THE MARYLAND-NATIONAL CAPITAL PARK AND PLANNING COMMISSION
Office of the Chairman, Montgomery County Planning Board

MEMORANDUM

REVIEW TYPE: Site Plan
APPLYING FOR: 23,458 sf auto sales and service
PROJECT NAME: Middlebrook Industrial Park
CASE #: 8-02013
REVIEW BASIS: Site Plan Review required for Auto Sales in this zone [59-C-5.21]
Additional requirements per 59-C-4.367

LANDSCAPE and LIGHTING PLAN
LOT 9, BLOCK A
MIDDLEBROOK INDUSTRIAL PARK

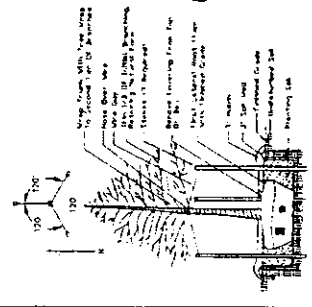
- b. Landscape Plan
 - i. Landscape Buffer Provide substantial increase in landscape materials for the entire 50-foot landscape buffer along I-270 to achieve adequate screening, including: a continuous primary planting row at the north property line of

mixed American Holly, Leyland Cypress, Pin Oak, Viburnum, and London Plane trees (30 additional trees); and a second continuous row of trees within the buffer midway between the first row and the parking area curb edge (60-70 trees); provide understory plantings throughout; trees to be installed at 8-10 feet in height or 3-inch caliper.

- ii. Shade Trees Provide three additional red maple shade trees for each island within the open parking areas; provide hedges 3-feet in height for full length of all landscape islands; provide two additional red maple shade trees and islands along north edge of parking facing I-270; provide shade trees at common property boundaries every 40 feet; provide additional street trees (Willow Oaks) on Amaranth Drive
- iii. Hedges Continue hedges around corners of all parking areas, to follow curb lines; provide hedges between shade trees on all landscape islands;
- iv. Plazas Provide additional landscaping and fixed planters for the plaza areas; provide details of paving, all fixtures and furnishings.

- iv. No free standing signs or pylon signs shall be permitted;
- v. Relocate all light poles out of the conservation areas;
- vi. Provide photometric light distribution plan that includes calculations for street lighting on Amaranth Drive and light level overlap;

- vii. Provide sectional drawing of I-270 showing building and fixture height(s) and viewing angles from I-270;
- viii. Provide Lighting Calculations Summary showing average/maximum and average/minimum ratios; provide calculations for all property lines;

MIDDLEBROOK INDUSTRIAL PARK
 SITE DEVELOPMENT PLAN
 LOT 9, BLOCK A
 8TH ELECTION DISTRICT, PHOENIX, ARIZONA
 PROJECT NO. 158 PLOT 17502
 ENGINEER: MERRICK HENDRICKS & GIBSON, P.A.
 1000 N. CENTRAL AVENUE, SUITE 1000, PHOENIX, AZ 85004
 PHONE: (602) 254-1000
 FAX: (602) 254-1001
 DATE: 08/15/00

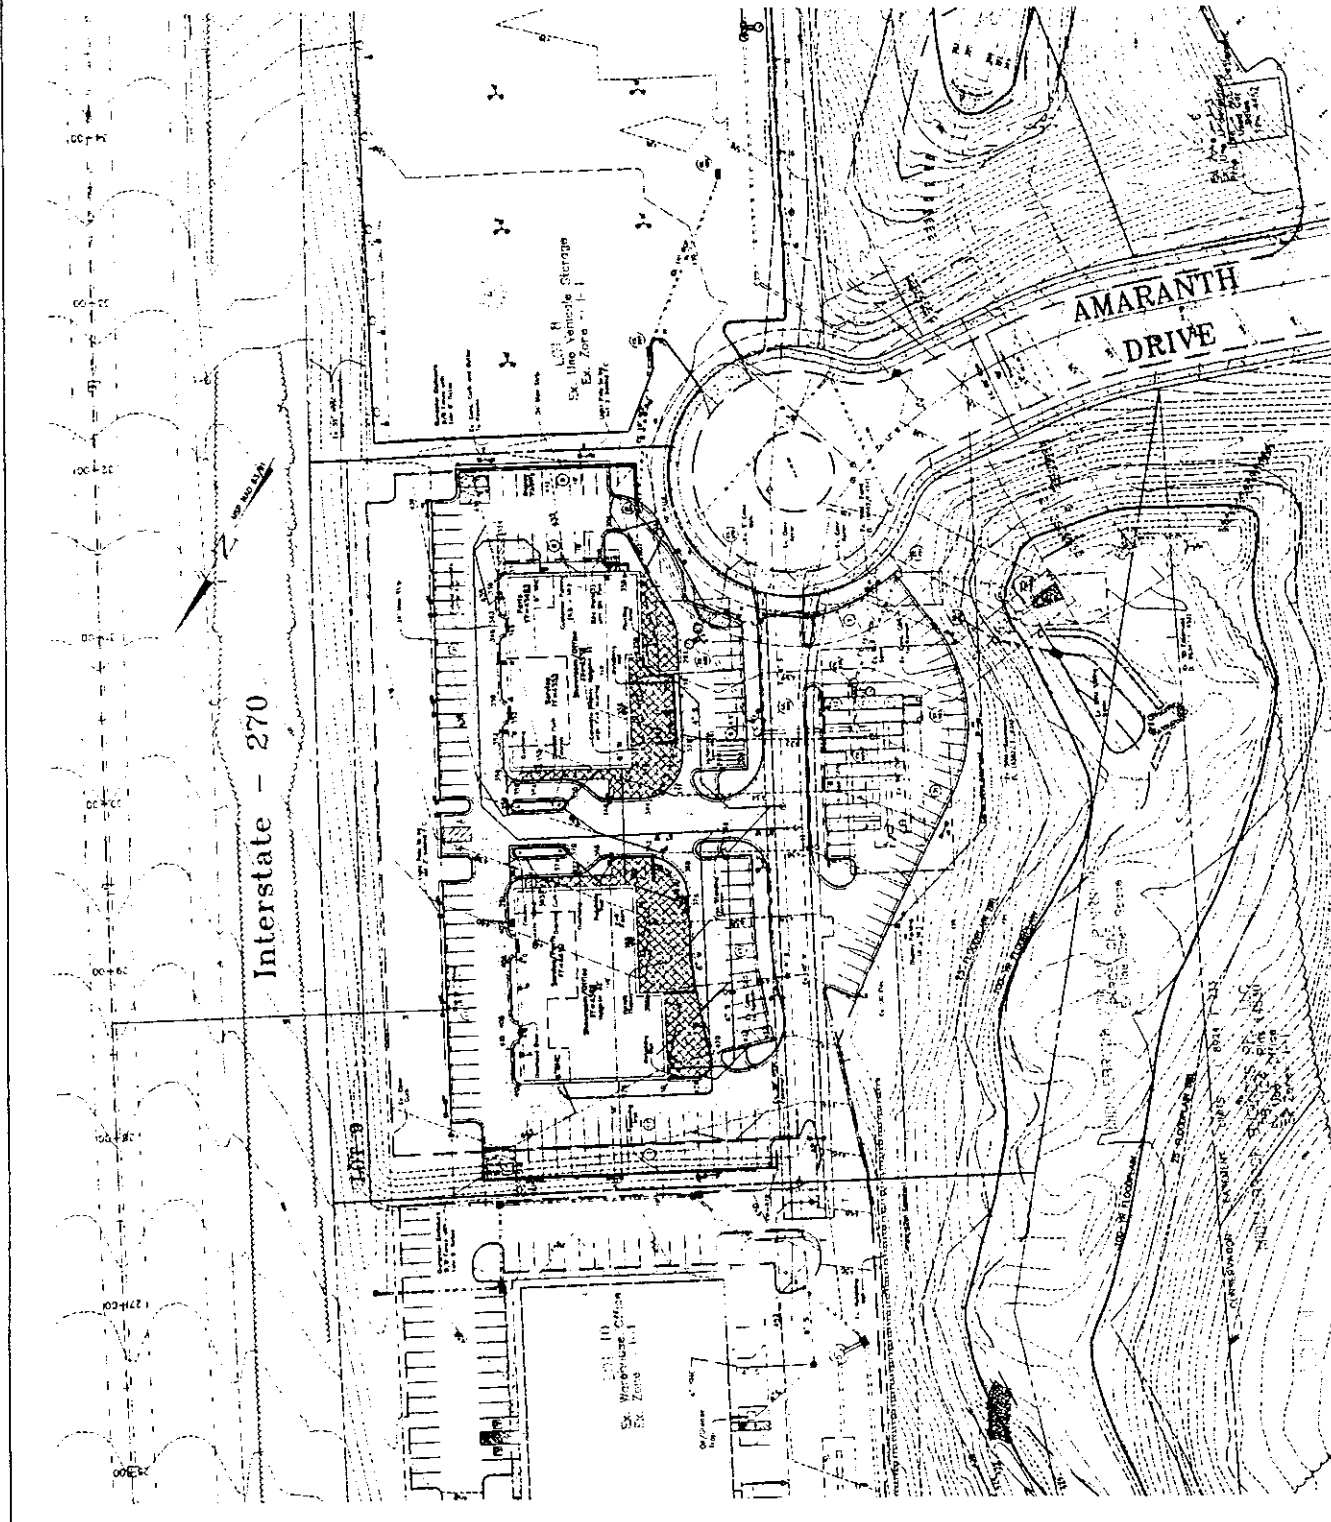
5. Prior to signature set, applicant must provide the following information or revisions, subject to staff review:
 - a. Site and Development Plan
 - i. Show north arrow, LODs, road dedications, road centerlines and dimensions, access easements, forest conservation easements, PUE, PIE, storm water parcel boundary; placement and dimensions of sidewalks, storm drain outlets, oil/grit separators;

- ii. Provide demolition plan showing removal of existing curbing and paving located within the proposed landscape buffer area; relocate and revise striping to comply with setback requirements and site plan requirements;

- iii. Provide fence or guard rail for protection of the landscape buffer; fence or guard rail should be black in color, to follow the paving boundaries on the east, south and north sides; the existing fence on the property line along the ROW should be replaced with one black in color; provide details and specifications for fencing, subject to staff review; to be noted on plan;

- vi. Provide details for all retaining walls and show top and bottom elevations; retaining walls to be constructed of masonry materials; no retaining walls to be located within 50 feet of the stream; retaining walls visible from I-270 shall be stone-faced;

- vii. Relocate each handicapped parking space(s) closer to each sales building; provide painted crosswalk for each; increase the size of landscape island along the north edge of parking area and locate at the center axis between the two buildings (and between the handicapped parking);

- viii. Provide curb return for landscape island near driveway entrance; remove one row of tandem spaces;
 - ix. Provide crosswalks for all pedestrian paths.
